DATE March 22, 2017**PROJECT No.** 1658927_106_TM_MAAOption2_R0**TO** Ryan Vanengen
Agnico Eagle Mines Limited**CC** Julien Lacrampe, Dionne Filiatrault, Lasha Young**FROM** Serge Ouellet**EMAIL** serge_ouellet@golder.com**WHALE TAIL LAKE CHANNEL – OPTION 2**

Figure 1: Photosat colour elevation image (Photosat 2015)

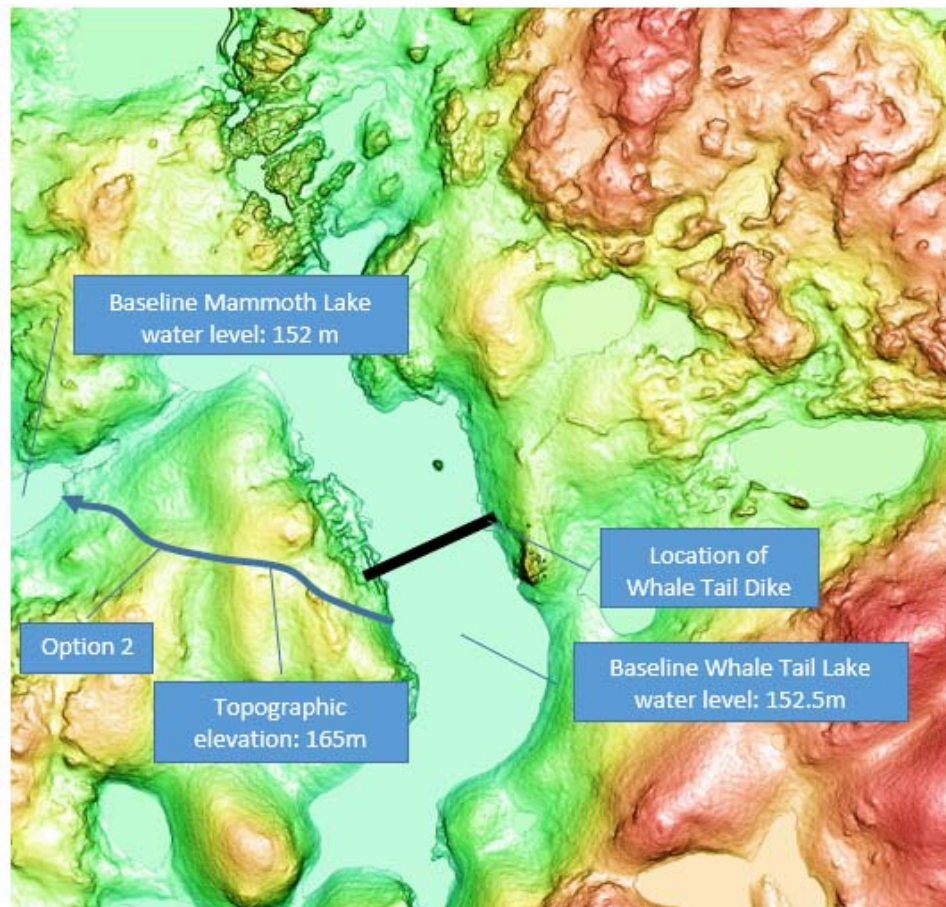
- 1) Option 2 would require a complex infrastructure requiring a large and deep trench into thick and frozen ground (overburden and rock):
 - a) Based on Photosat (2015), the highest difference of elevation between the two lakes along the path of the channel is 12.5 m (Figure 1).
 - b) To avoid the change in elevation of Whale Tail Lake, the channel would need to be designed with a width similar to the passage between Whale Tail Lake and Mammoth Lake which is approximately 50 m. This width is not accounting for the slope of the walls (resulting in a larger footprint in surface) that would have to be developed and maintained to ensure stability in the rock and in the overburden that will thaw.
